**BID-TIME ADDENDUM # 1**

December 2, 2022

Murrieta Elementary School  
Murrieta Valley Unified School District  
App. # 04-119432, File # 33-32

DLR Group | BakerNowicki Design Studio  
731 Ninth Avenue, Suite A  
San Diego, CA 92101

# 4017 MURRIETA ES - PHASING PLAN 12/1/2022

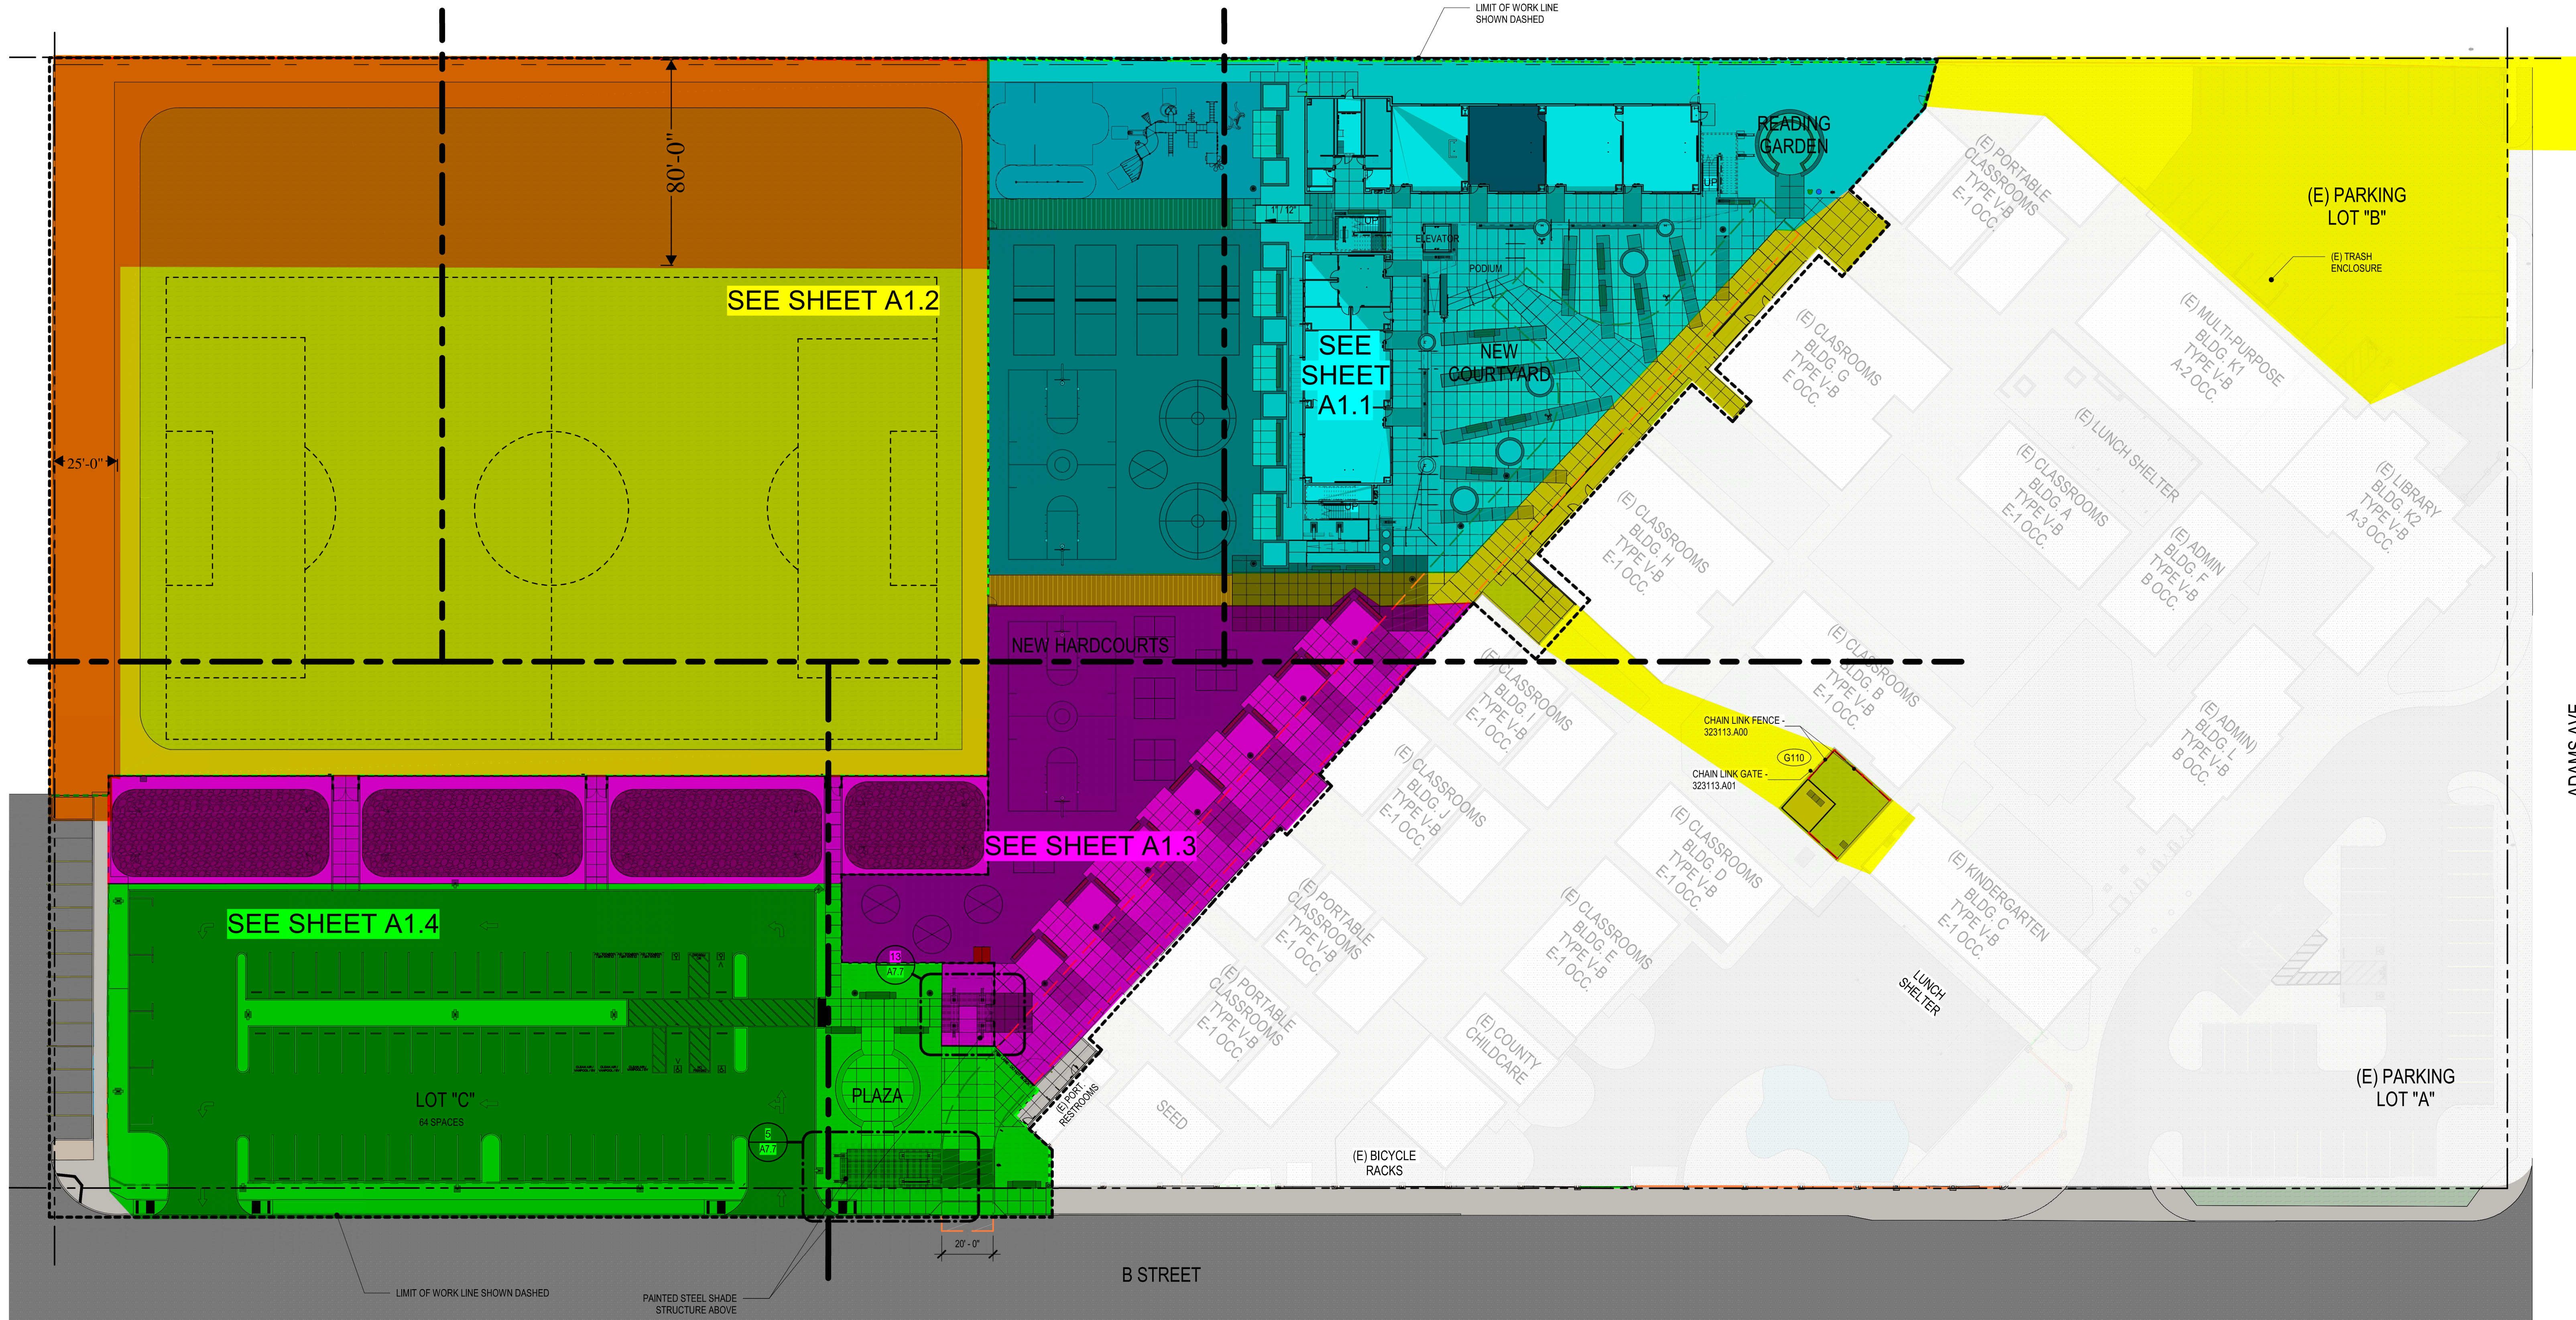
- A. Schedule was not originally included in contract documents, but is incorporated into the contract documents via this bid-time addendum 01. See attachments section for preliminary construction schedule and phasing plan.
- B. Site utilization plan is also attached and therefore incorporated into the contract documents. Information included in the site utilization plan is as follows:
- a. Installation and relocation of temporary fencing, and construction gates per phasing of project to be included in BP#1. Whenever possible temporary fencing will need to be secured to the ground via stakes in lieu of sand bags. Coordinate with CM Superintendent for direction on when and where this condition will occur.

# 4017 MURRIETA ES - SITE UTILIZATION PLAN 12/1/2022

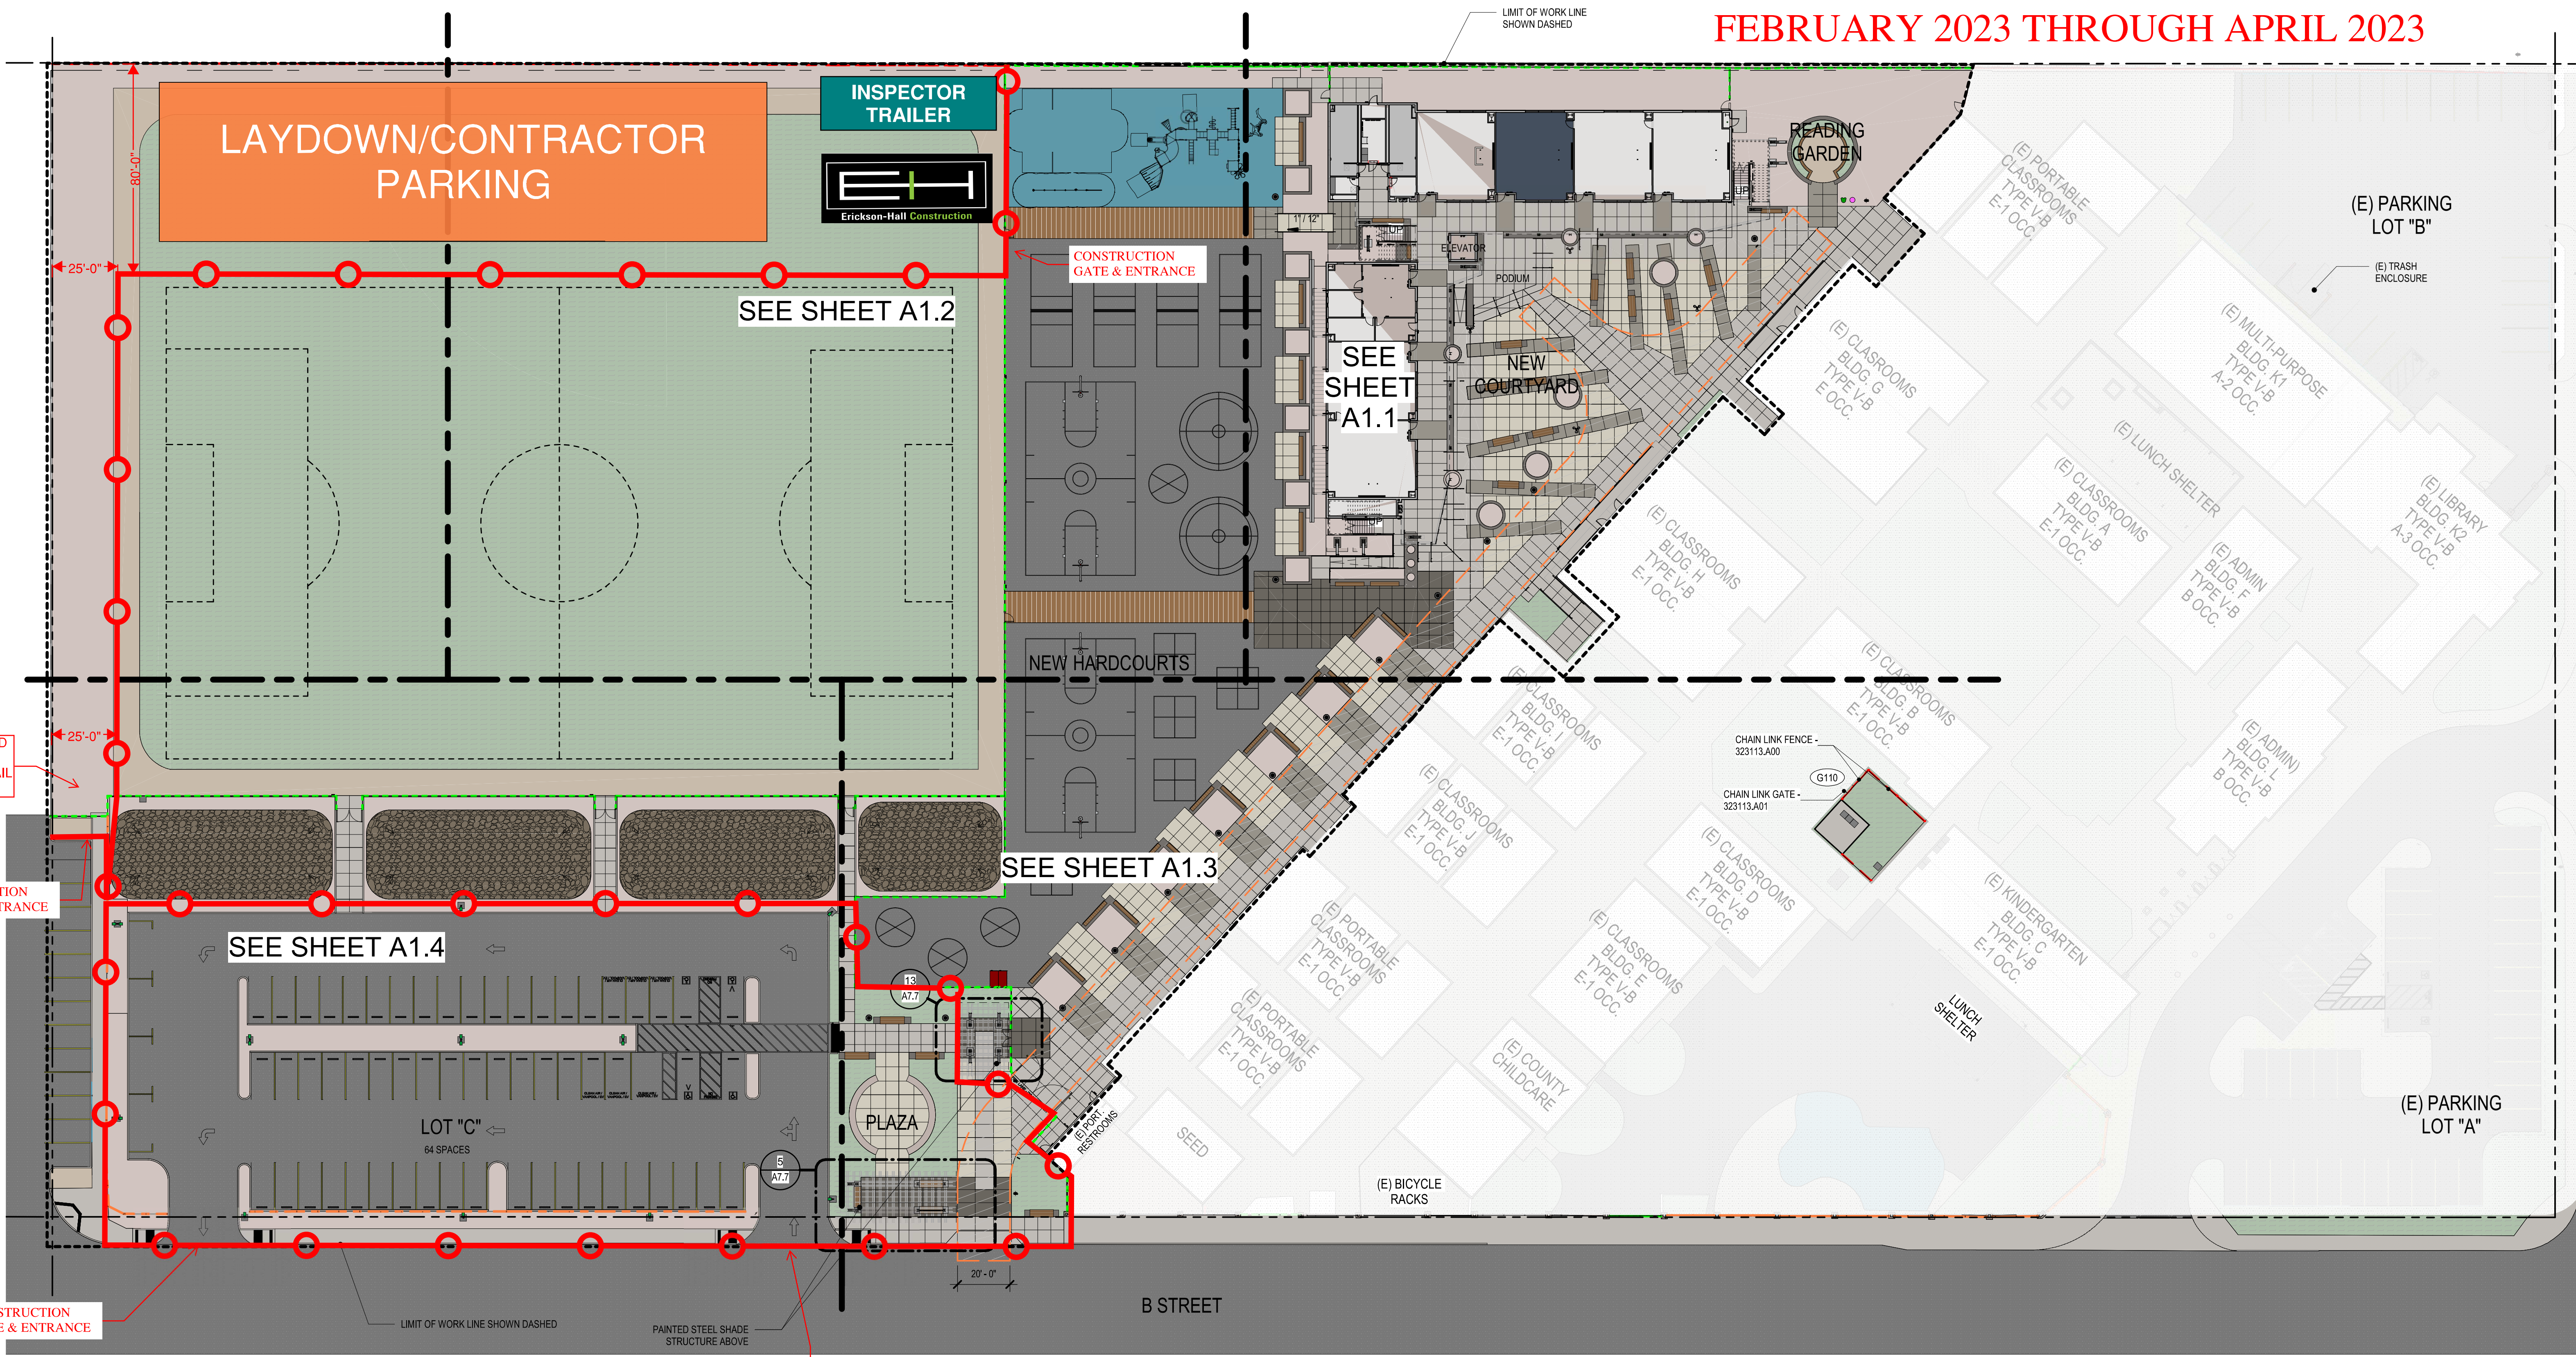
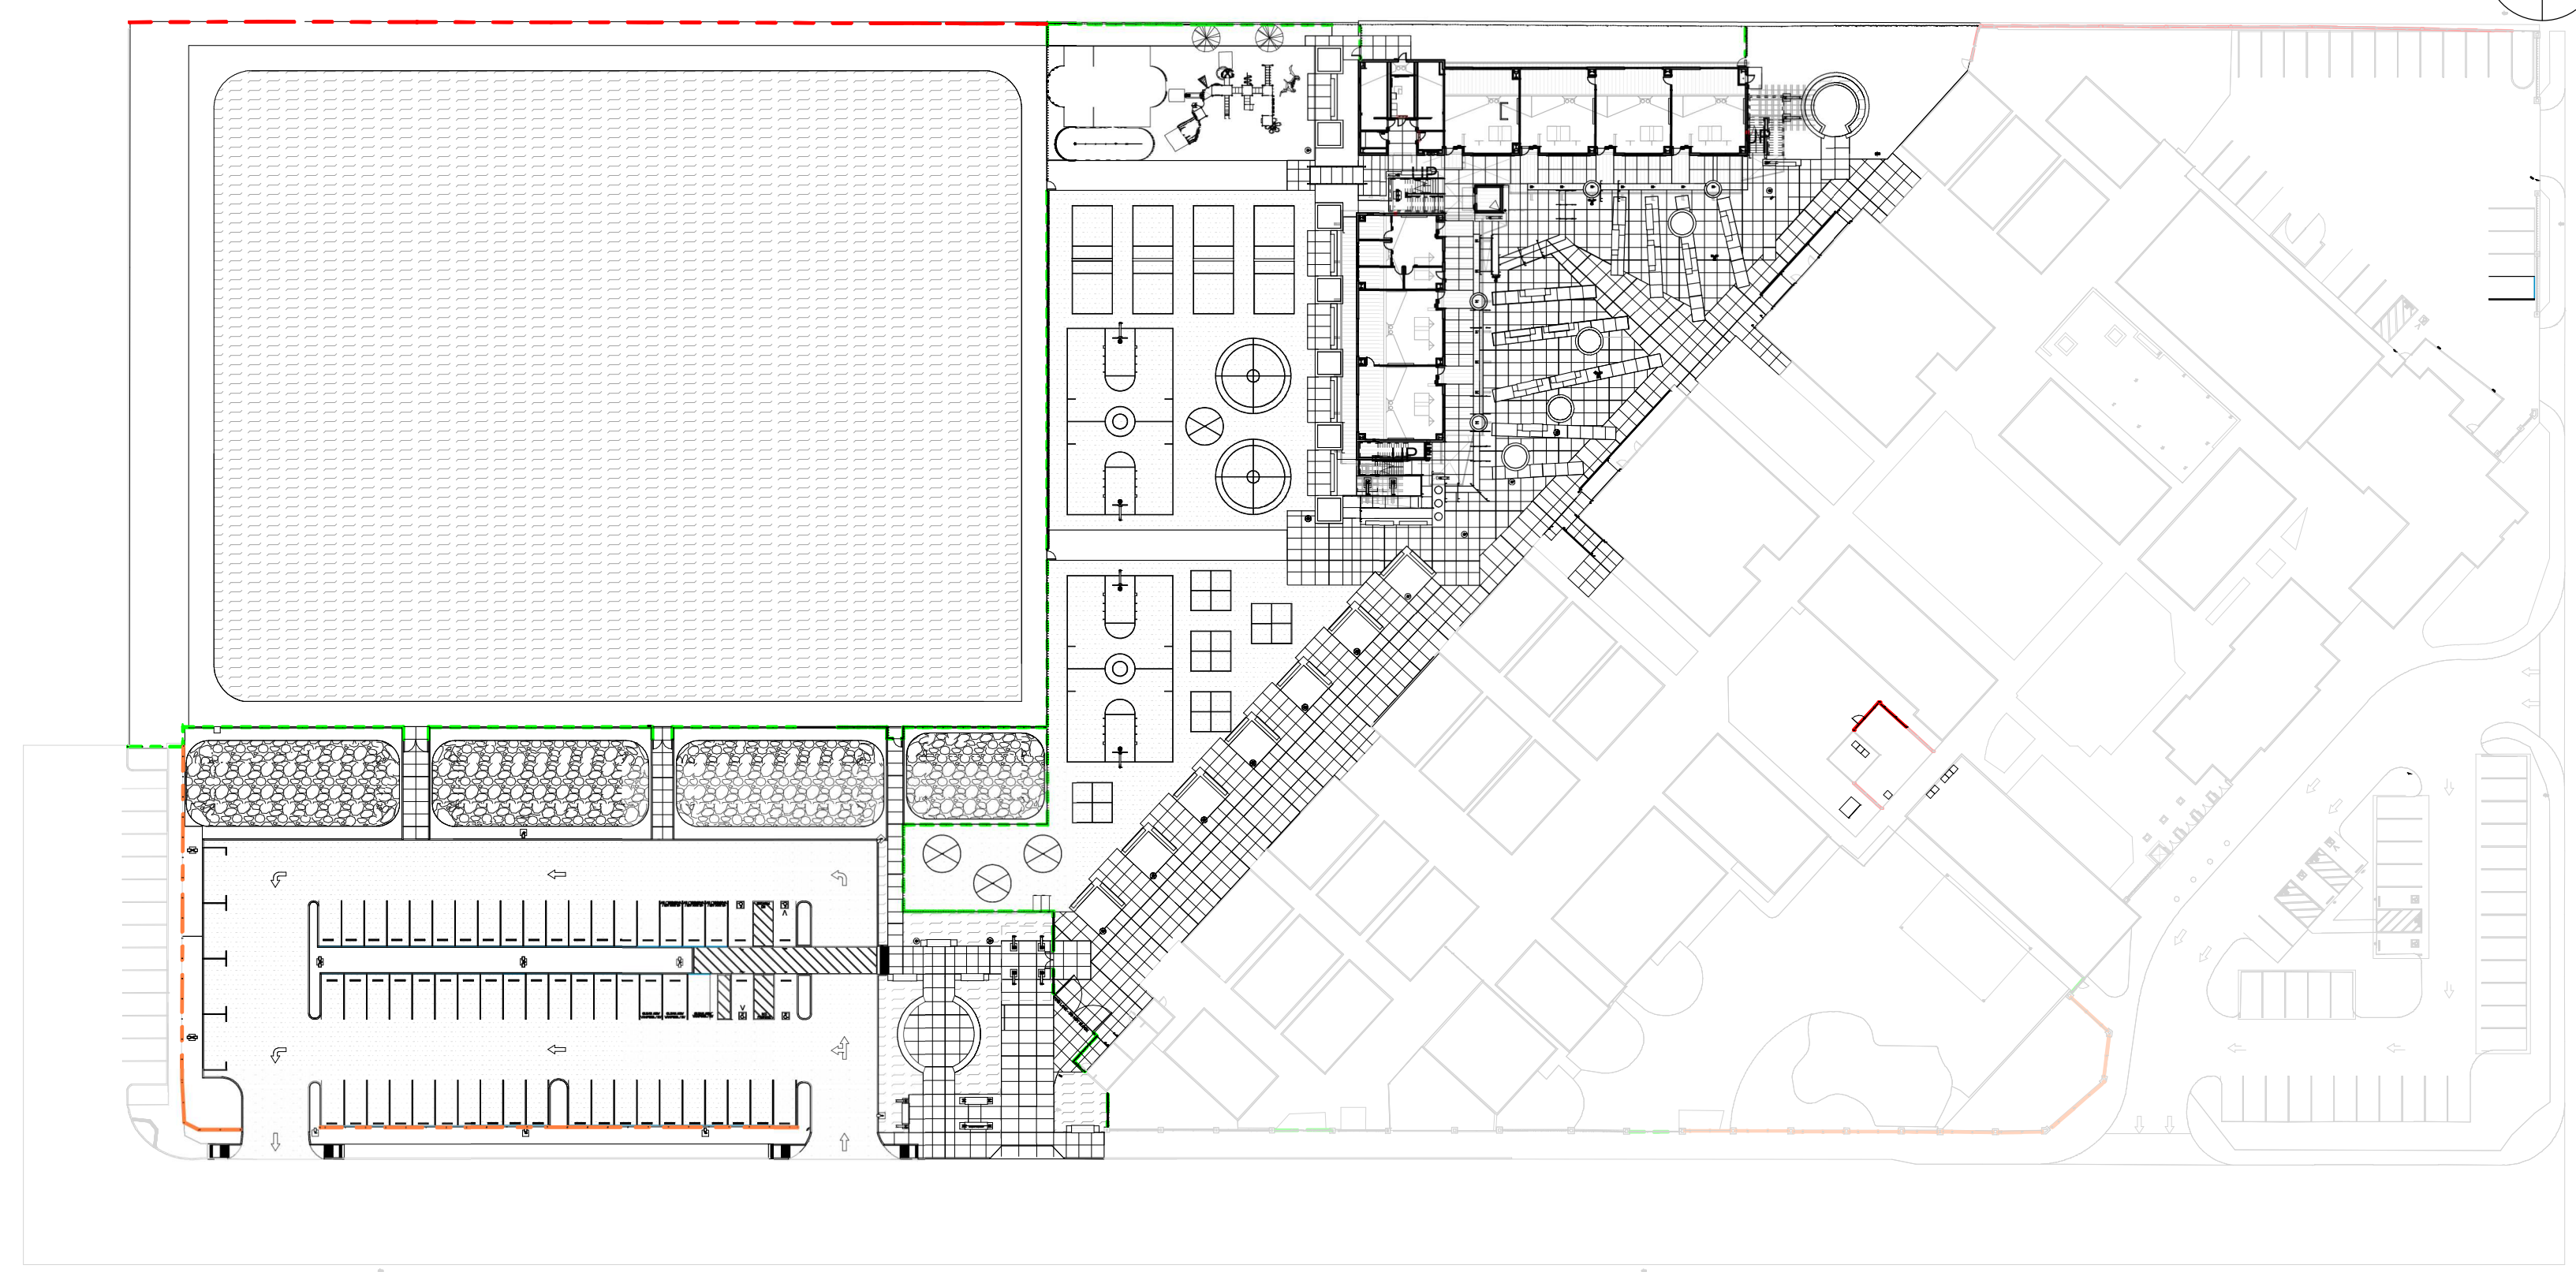
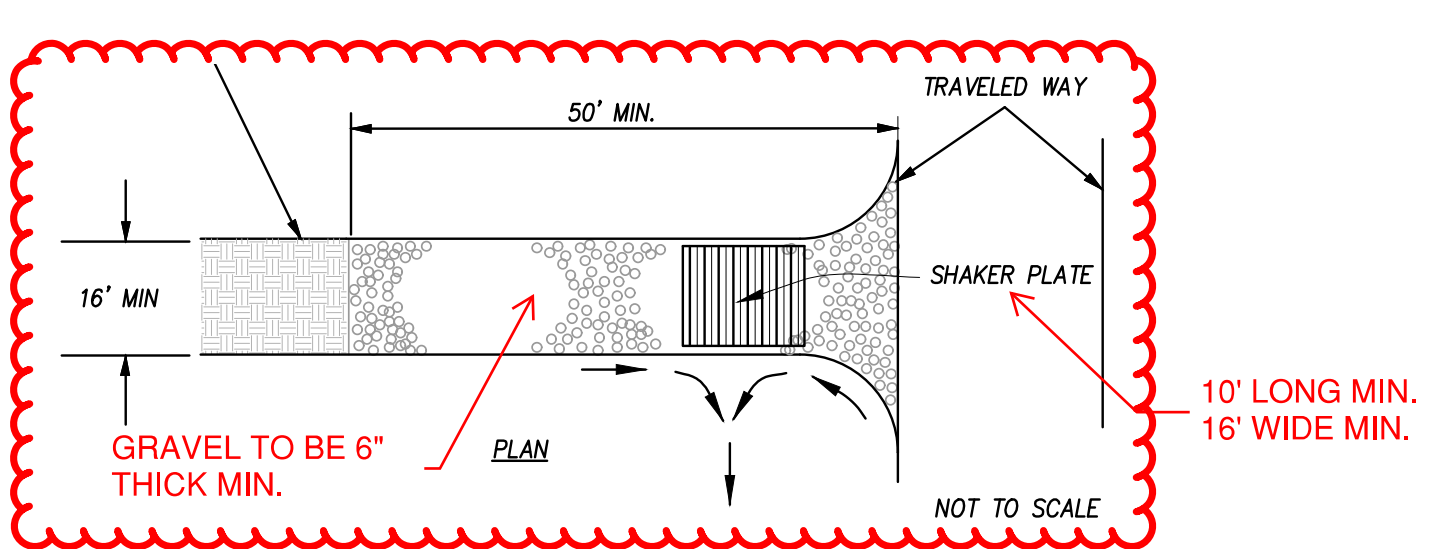
- b. Installation and relocation of CM and Inspector trailers for temporary utilities connection and disconnection as needed. Furnishing and installing temporary electrical to construction trailers to be included in BP#15. Disconnect, hook-up and relocation as directed by CM Superintendent.
- c. PTC Storage Area
- d. PTC Parking Areas
- e. Construction Entrance requirements for BP#1.
